Item 4.**Development Application: 14-18, 20-24 and 26-30 Lee Street and 1 Eddy Avenue, Haymarket - D/2021/251****File No.:** D/2021/251**Summary**

Proposal Summary:

Figure 58: Typical Tower (left) and typical podium (right) compliance plans

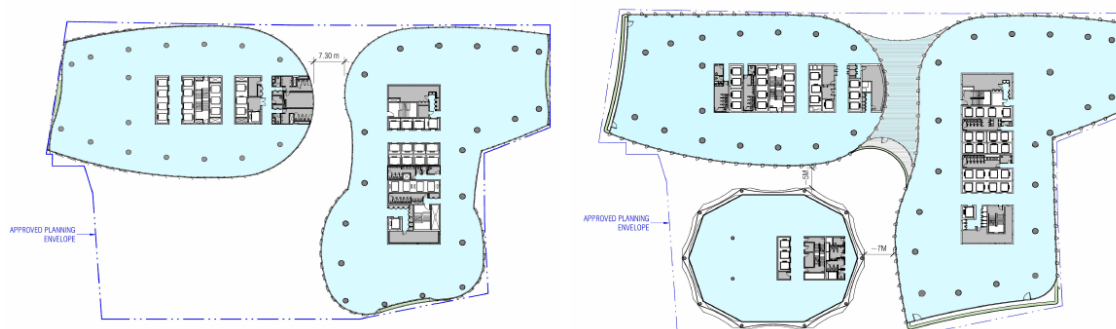
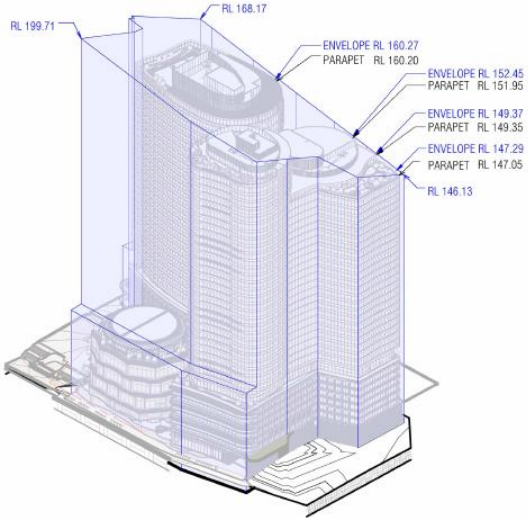
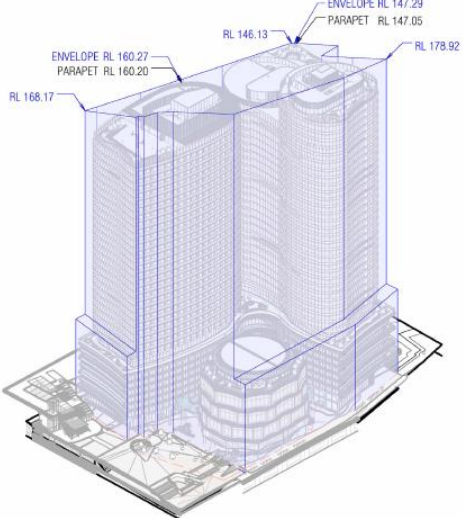
Provision	Compliance	Comment
		<p>podium that has the same façade alignment as the podium if the building design responds to its surrounding context, has no detrimental impacts to the publicly accessible managed space and public domain and the façade incorporates articulation that effectively reduces visual bulk and mass of the building</p> <ul style="list-style-type: none"> • Maximum podium height of RL 63.8 • Maximum tower height plane between RL 205.8 and RL 147.7, established by the Sun Access Plane to protect solar access to Prince Alfred Park. <p>As indicated in Figures 58 and 59, the proposed development is contained wholly within the planning envelope established by the provisions above and the maximum height, GFA and solar protection development standards prescribed in Sydney LEP 2012.</p> <p>Additionally, the proposed development provides a building separation of 30 metres from the Atlassian development. The proposal also does not exceed the 80% envelope efficiency. Specifically, the podium presents an envelope efficiency of 66.1% and 50.56% for the tower.</p>

Figure 62: Comparison of the previously submitted (left) and proposed (right) Day 2 Upper Ground Floor Plan, demonstrating integration with the Toga Central development.

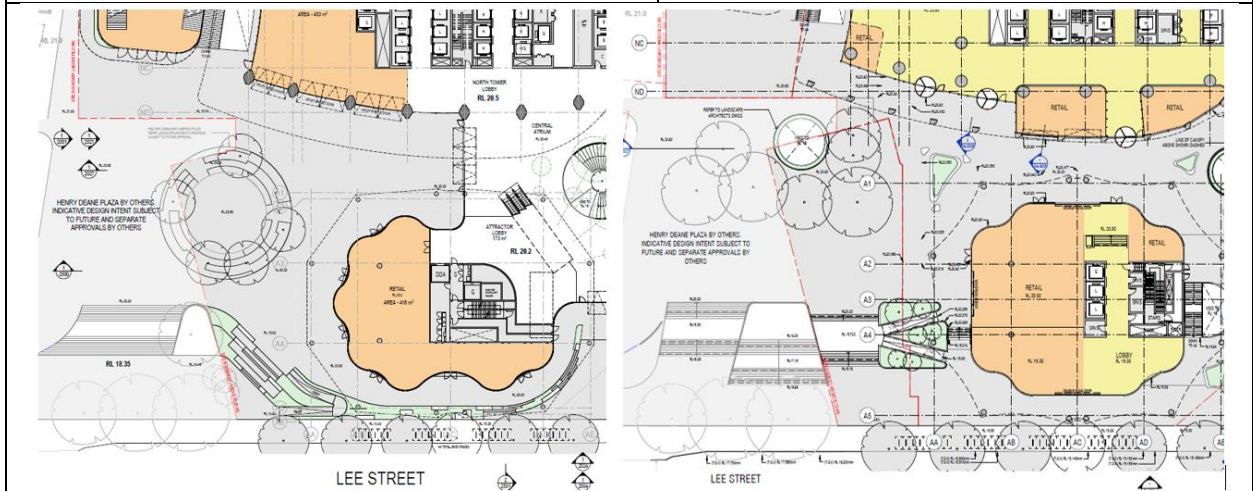
Recommendation	Response
	<p>21, as indicated in Figure 62 below. An extract of the current Toga Central ground floor plan in Figure 63 illustrates a larger aperture from Lee Street and central oculus is provided. Ongoing collaboration between Dexu Frasers and Toga Central are being had to ensure the final resolution of the public domain is well integrated.</p>

Figure 64: Comparison of the previously submitted (left) and proposed (right) Day 1 Upper Ground Floor Plan, demonstrating improved relationship to Lee Street.

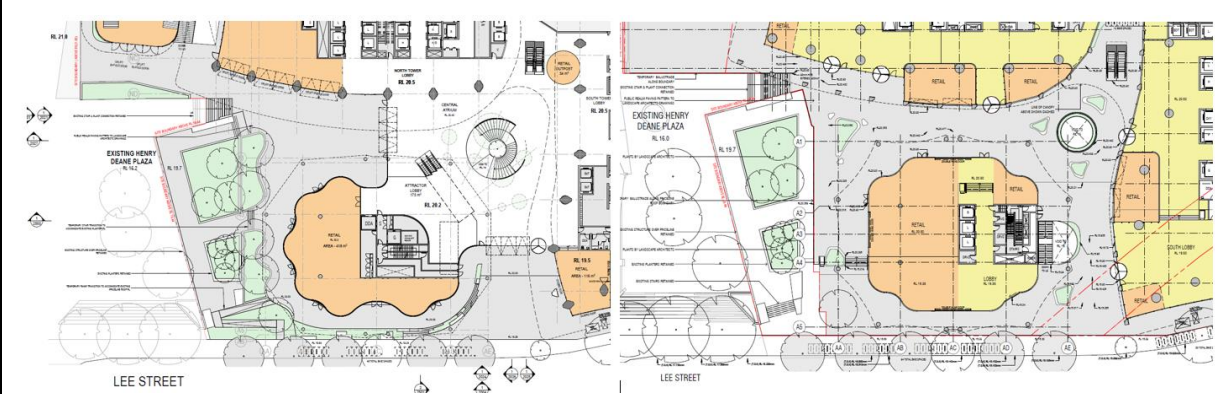
Recommendation	Response
	<p>A comparison between the previously submitted Upper Ground Floor Plan (presented to the Subcommittee), and the amended plan is provided in Figure 64 below. The proposed development has improved the relationship of the upper ground level to Lee Street by removing stairs, ramps and landscaping that hindered permeability from the street. Unhindered and direct access is provided to the site from Lee Street.</p>

Figure 65: Comparison of the previously submitted (left) and the proposed (right) Upper Ground Floor Plan.

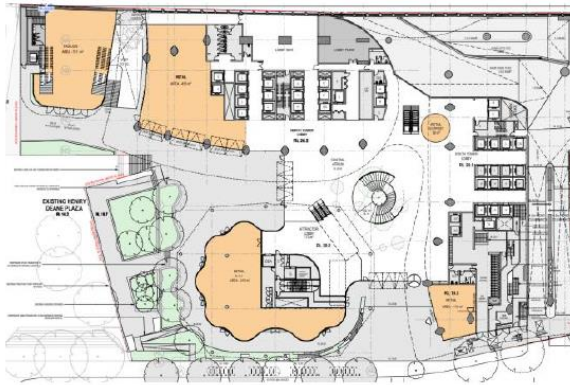
<p>Clearly defined retail uses need to be provided adjacent to the lift lobbies and in the plaza level of the 'Connector' to increase activation.</p>	<p>The proposal has been amended to remove the enclosed atrium and reinstate a public domain that is open to sky to create a 'laneway' environment. Retail uses have been included within the lobby areas of the towers and the Connector that are also open to the laneway to enhance activation on the plaza level. Refer to Figure 65 below.</p> <p>The laneway environment is also reproduced on the lower ground floor as per Figure 66. Access has been relocated from the oculus on the south-western corner towards Lee Street for more direct access from the street and has the potential to connect to the Goods Line.</p>
---	---

Figure 79: Locations exceeding the 24 m/s Wind Safety Standard in Configuration 3 (left) and Configuration 4 (right).

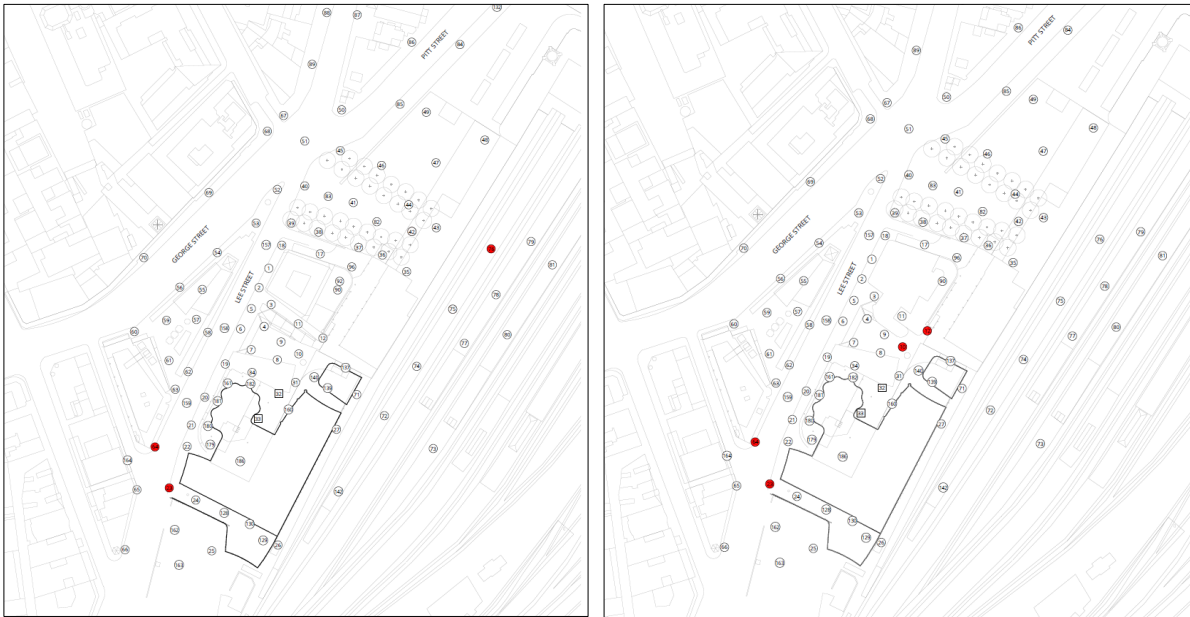
120. Locations 23 and 64 relate to the basement carpark entry from Lee Street (23) and the footpath on the corner of Lee Street and Little Regent Street (64) and demonstrate exceedances in both Configurations when the proposed development is constructed.
121. Having regard to Configuration 4 as the final case scenario, consideration is made to cumulative wind environment on the broader area and the degree of the exceedance at Locations 23 and 64 as well as the two locations around the Toga Central development (Locations 10 and 12).
122. The exceedances in these locations range from 24.3 m/s at a minimum and 25 m/s at Location 12 at the corner of the Toga Central development and link to future Central Square. The exceedance by 1 m/s relates to the reference design of Toga Central and could be addressed as part of the future detailed design and landscaping of that space.

Figure 80: Wind comfort conditions of the elevated levels of the proposed development in Configuration 4.

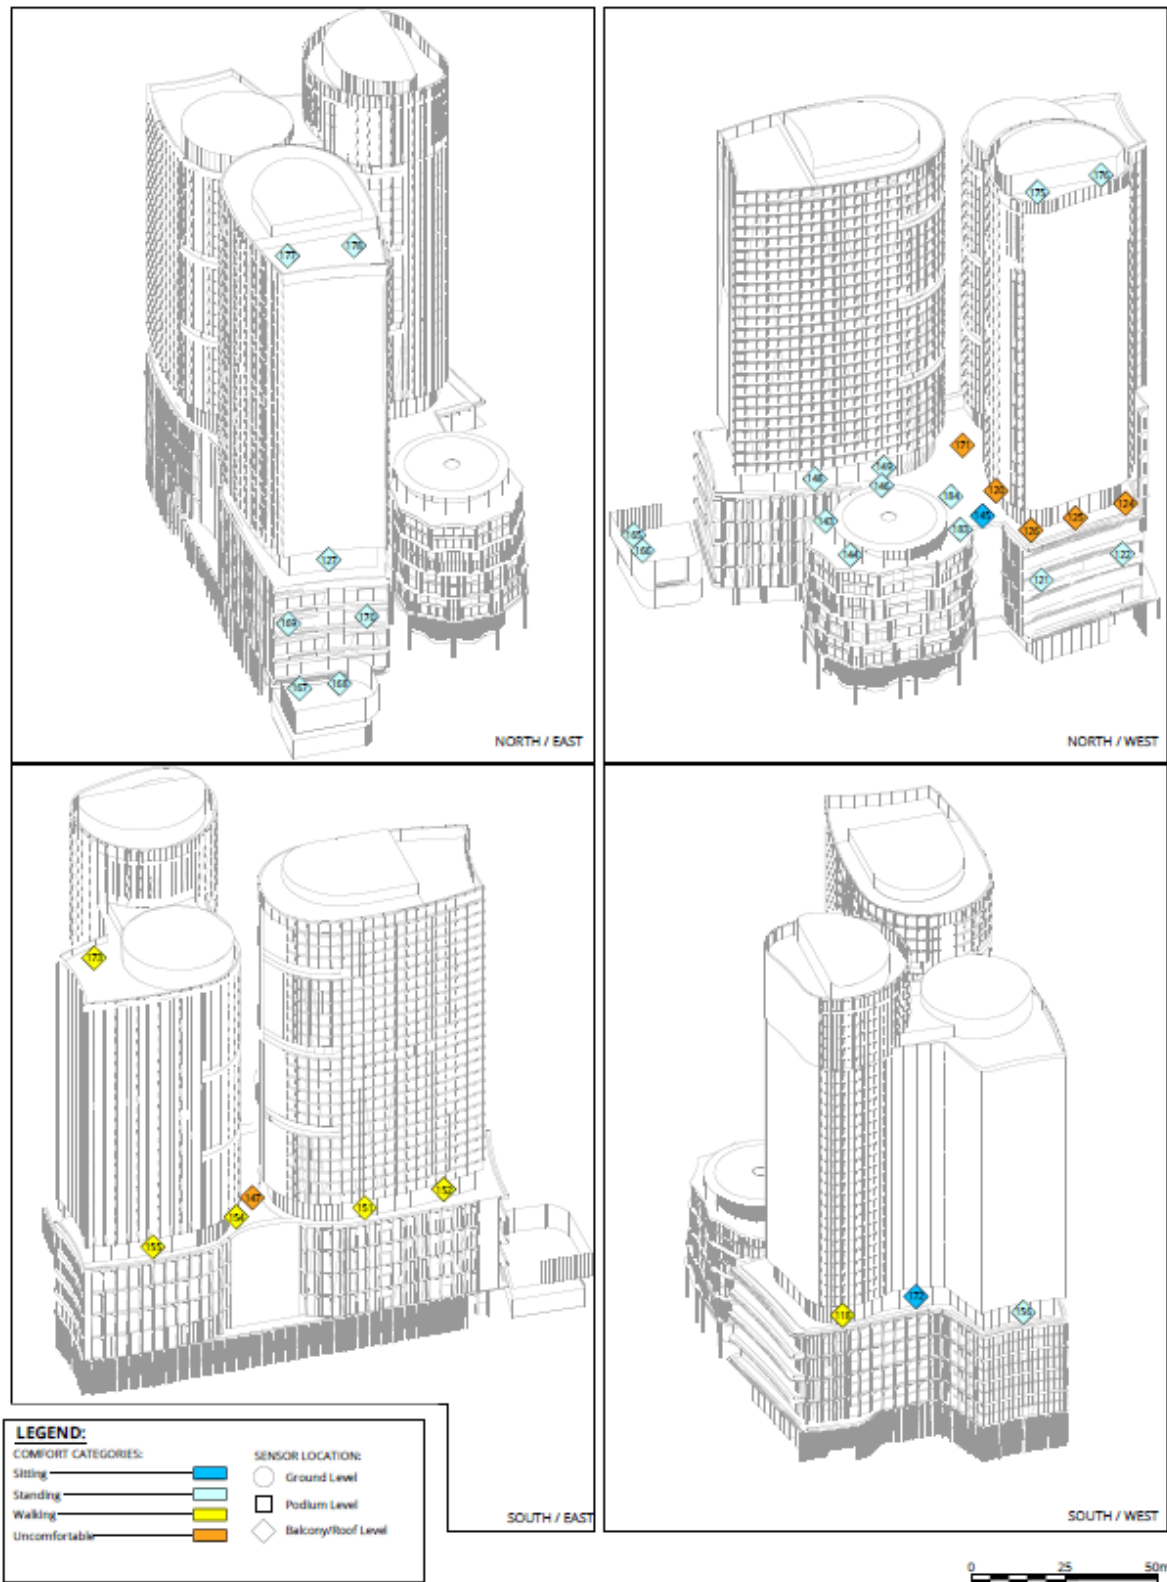
126. Whilst the wind tunnel testing in the Report confirms the proposed development can provide a safe and comfortable wind environment at pedestrian level, the Report has identified that open spaces on the podium terraces and tower rooftops are affected by wind and are only suitable for standing and walking. Critically, the Report identifies areas of the Level 8 podium terraces are uncomfortable and exceed the 24 m/s wind safety criteria, as indicated in Figure 80 below.

129. The application was reviewed by Council's Landscape Officer who raised significant concern for the reliance on landscaping on the podium, tower, and rooftop levels to mitigate winds. As detailed elsewhere in this report, the landscape details are incomplete where planters and tree planter details and plant schedule are lacking. The landscape design does not provide sufficient details of the tree planters on slab to confirm if there is adequate soil depth and volumes for the trees to survive and provide effective wind mitigation.

130. Accordingly, conditions of consent are recommended in Attachment A for revised plans, landscape details and Wind Impact Addendum to be submitted that incorporates any changes proposed to improve the wind environment for the development to ensure open spaces on the podium and tower rooftop are fit for purpose.
